# Access Compliance Report

## Public Rights-of-Way

Intersection ID: 31837	Main Street: VICKSBURG_RD	Cross Street: WILLS_WY	Location: E
ADA ID: 6F7FA3407C48	Ramp Type: PerpDiag	Initial Pass/Fail: Fail	Overall Compliance: No
		Severity Score: 37.5

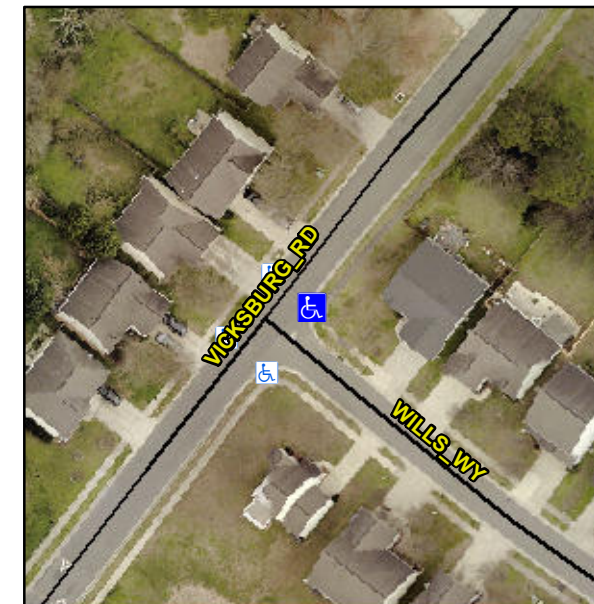
**R304.2.2, R304.5.3**

Compliance	Description	Data	Compliance	Description	Data
N/A	Ramp Length (in)	47.0	No	Ramp Slope (%)	9.3
Yes	Ramp Width (in)	50.0	No	Ramp XSlope (%)	14.1
N/A	Flare Type LT	N/A	N/A	Flare Type RT	N/A
N/A	Flare Slope LT (%)	N/A	N/A	Flare Slope RT (%)	N/A
N/A	Flare Traversable LT?	N/A	N/A	Flare Traversable RT?	N/A
N/A	Landing Length (in)	N/A	N/A	DWS Provided?	N/A
N/A	Landing Width (in)	N/A	N/A	DWS Contrast?	N/A
N/A	Landing Slope (%)	N/A	N/A	DWS Length (in)	N/A
N/A	Landing X Slope (%)	N/A	N/A	DWS Full Width?	N/A
N/A	Landing Curb? (Y/N)	N/A	N/A	DWS Offset (in)	N/A
N/A	Shared Landing?	N/A			
N/A	Gutter Ponding?	N/A	N/A	Gutter Slope (%)	N/A
N/A	Gutter Lip Ht (in)	N/A	N/A	Gutter X Slope (%)	N/A
N/A	Painted X Walk1?	No	N/A	Painted X Walk2?	No
	X Walk 1 Direction	To NW		X Walk 2 Direction	To SW
N/A	X Walk 1 Width (in)	N/A	N/A	X Walk 2 Width (in)	N/A
	X Walk 1 Slope (%)	7.1		X Walk 2 Slope (%)	9.9
	X Walk 1 X Slope (%)	9.3		X Walk 2 X Slope (%)	6.8

**Remove & Replace Curb Ramp With Two New Directional Ramps or Equivalent.**
